INSTRUCTION TO SERVICE

ITS:6405

Rework Heat Exchanger Cabin Loop Line and Routing

Figure 2: Cabin Heat Coolant Tube Removal

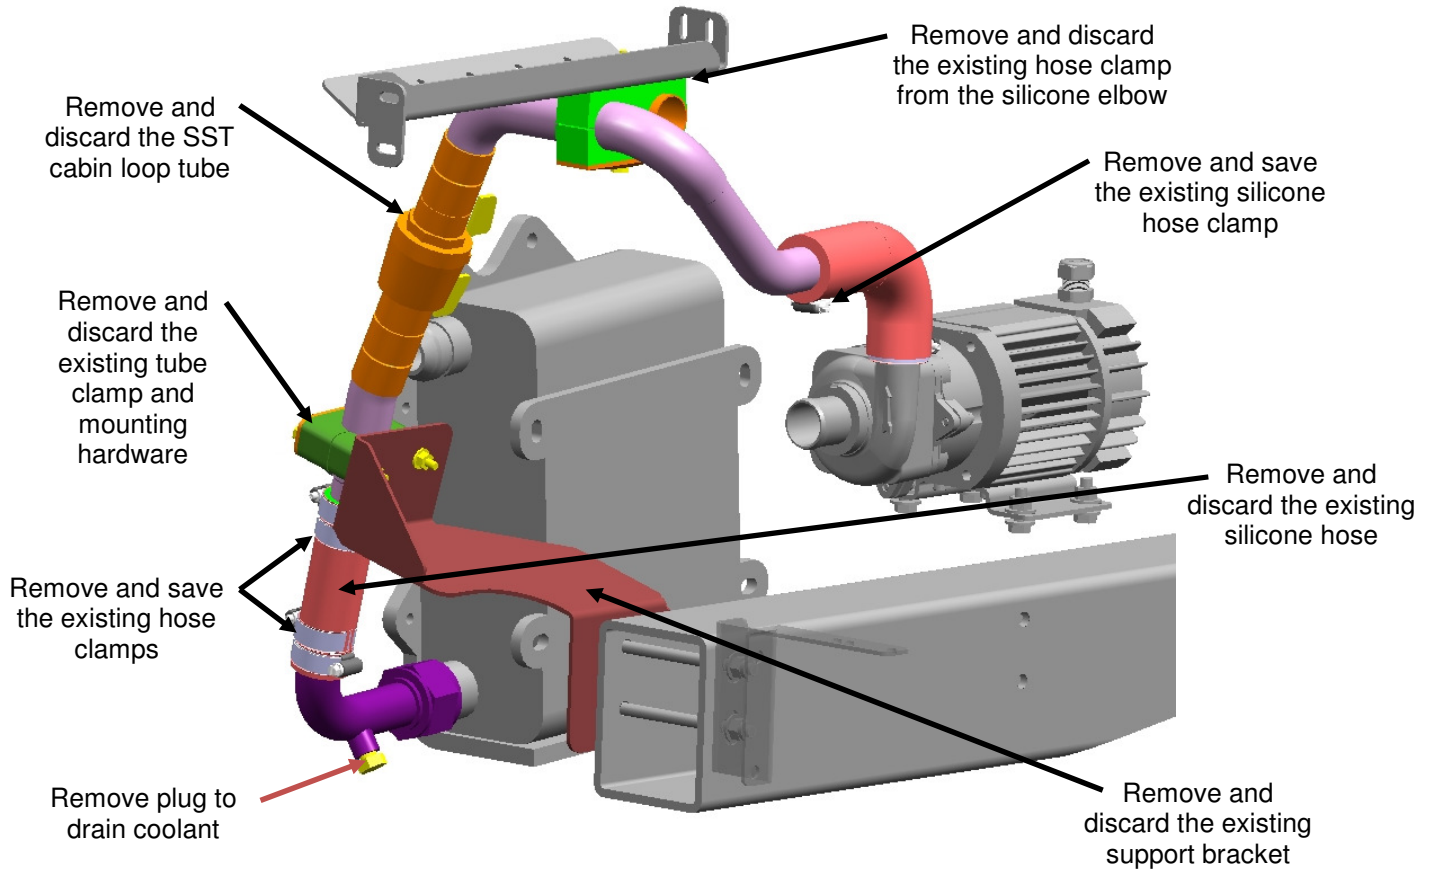
5. If necessary, raise the coach in accordance with the New Flyer Service Manual.
6. Remove and discard the existing tube clamp and mounting hardware supporting the heat exchanger cabin loop SST tube to the de-gas frame as shown in Figure 2.

7. Remove and discard the existing tube clamp and mounting hardware supporting the heat exchanger cabin loop SST tube to the clamp mounting bracket (bracket may vary in appearance) as shown in Figure 2.

8. The cabin heat coolant tube support clamp mounting bracket may vary in appearance, remove the bolts from the forward lower radiator tube mounting bracket, remove and discard existing cabin heat coolant tube bracket and re-install the lower radiator tube mounting bracket bolts. Torque bolt (x2) to 40-70 in*lbs dry, see Figures 2.

9. Remove and save the existing hose clamp from the silicone elbow on the booster pump line to the SST cabin loop tube, see Figure 2.
10. Remove and save the existing hose clamps (x4) from the silicone hose connecting the heat exchanger 90° SST elbow to the SST tube to the booster pump, see Figure 2.

11. Remove and discard the existing silicone hose and SST cabin loop tube, see Figure 2.

Figure 3: De-gas Frame Bracket Rework (as shown from the bottom)

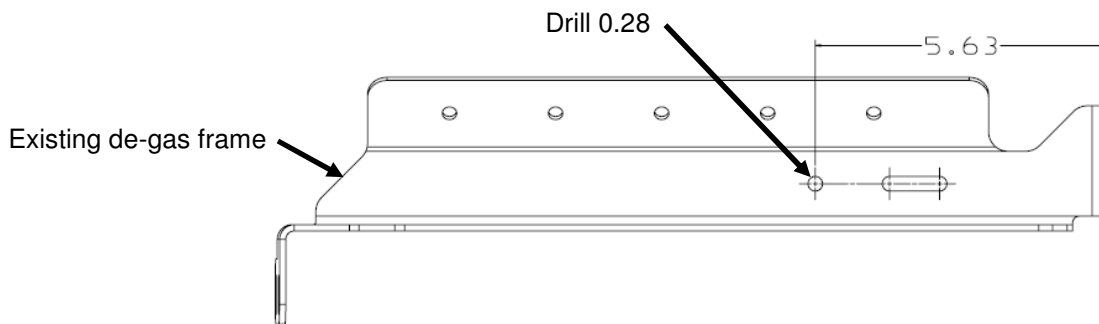
12. Mark and drill a 0.28 Dia clearance hole through the existing de-gas frame as shown in Figure 3.

Figure 4: Tube Assembly Installation

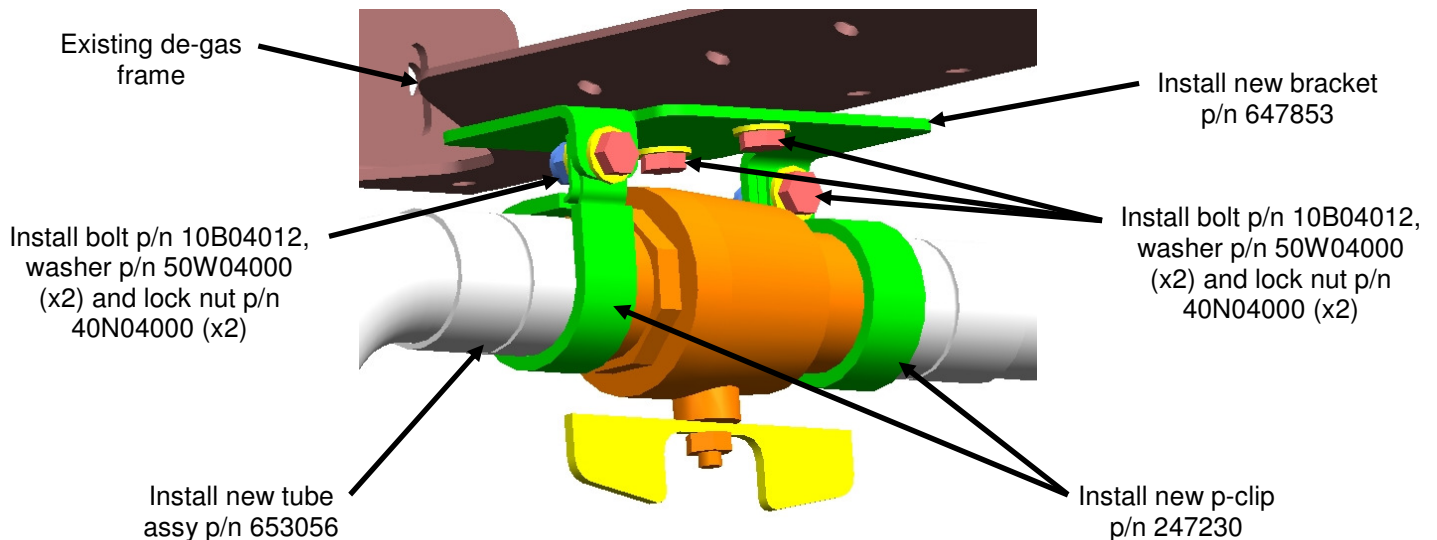
13. Using the newly drilled hole from Step 12 and the same mounting slot as the removed tube clamp from Step 6 install the new tube support bracket p/n 647853 to the de-gas support bracket using new bolts p/n 10B04012 (x2), washers p/n 50W04000 (x4) and lock nuts p/n 40N04000 (x2), torque hardware to 12 ft*lbs dry. See Figure 4.
14. Loosely install the new tube assy p/n 653056 to the newly installed bracket from Step 13 using p-clips p/n 247230 (x2), washer p/n 50W04000 (x4) and lock nuts p/n 40N04000 (x2). See Figure 4.

- When installing the new tube assy to the newly installed bracket, the end to the booster pump is to be loosely installed into the existing silicone elbow at the pump using existing clamp from Step 9. If existing silicone elbow is worn or does not fit correctly to the new tube assy it should be replaced with a new elbow p/n 606473. New elbow it to be trimmed to fit.

Figure 5: Cabin Heat Coolant Tube Assembly Installation

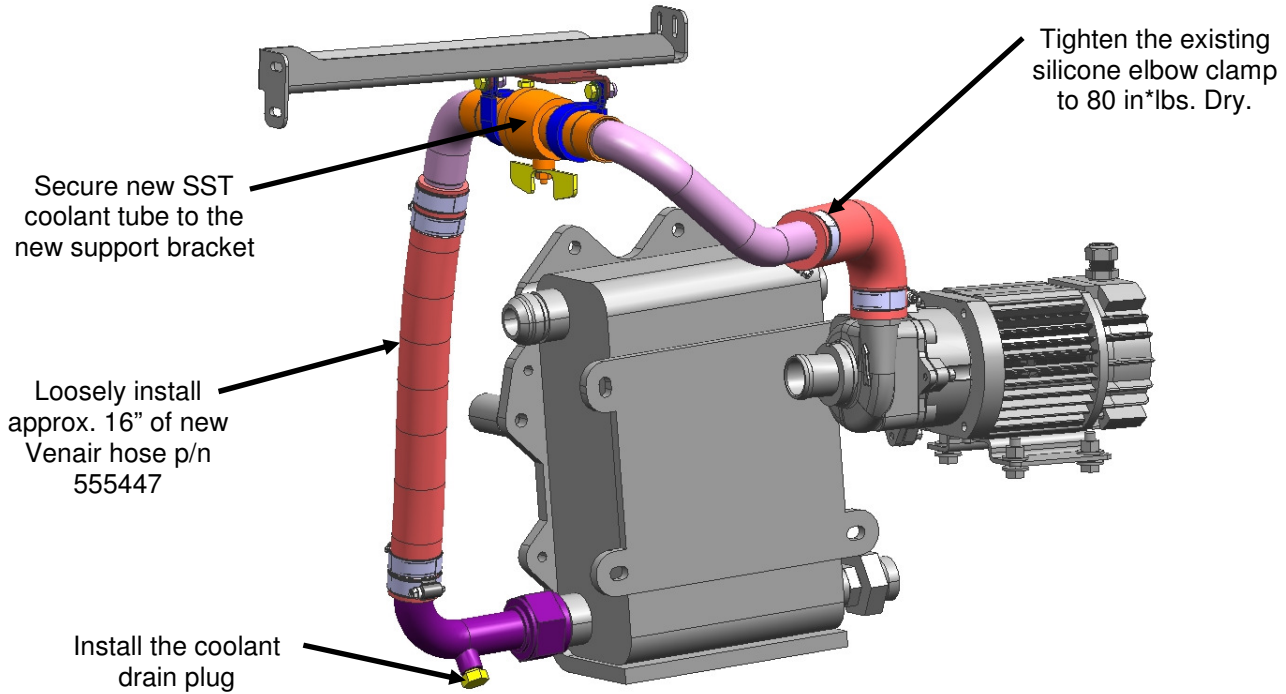
- Loosely install approx. 16" of new Venair hose p/n 555447 (trim hose to fit) between existing heat exchanger cabin heat SST elbow and newly installed tube assy from Step 15 using existing hose clamps removed in Step 10, qty's of clamps may vary depending on the install. See Figure 5.

- Ensure the silicone hose, silicone elbow and tube assy are free of kinks and the routed in a relaxed state and tighten clamps as follows.
 - Tighten existing tube assy p-clip hardware installed in Step 14 to 12 ft*lbs dry.

- Tighten the existing silicone elbow clamp from Step 15 to 80 in*lbs. Dry. Tighten at 75 rpm or less, re-torque to 80 in*lbs. at 75 rpm or less after 30 mins.

- Tighten the existing silicone hose clamps from Step 16 to 80 in*lbs. Dry. Tighten at 75 rpm or less, re-torque to 80 in*lbs. at 75 rpm or less after 30 mins.

Figure 6: Coolant Tube Assembly Support Clamp Removal

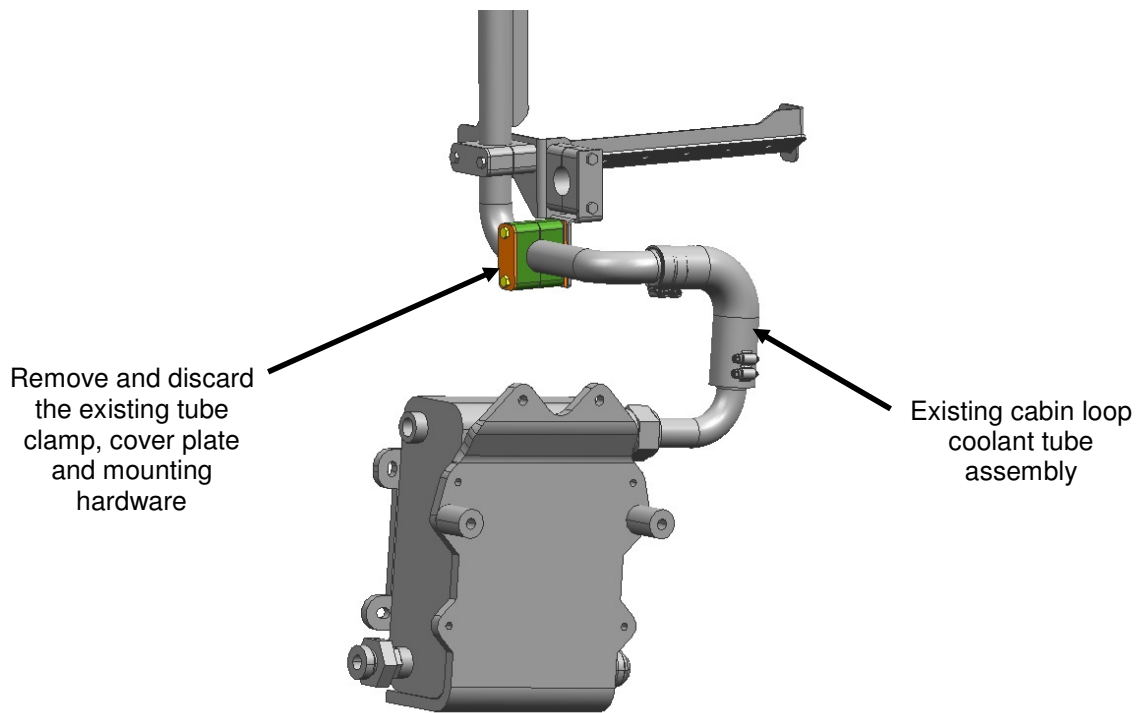
20. Remove and discard the existing tube assembly support clamp, cover plate and mounting hardware at the location shown in Figure 6.
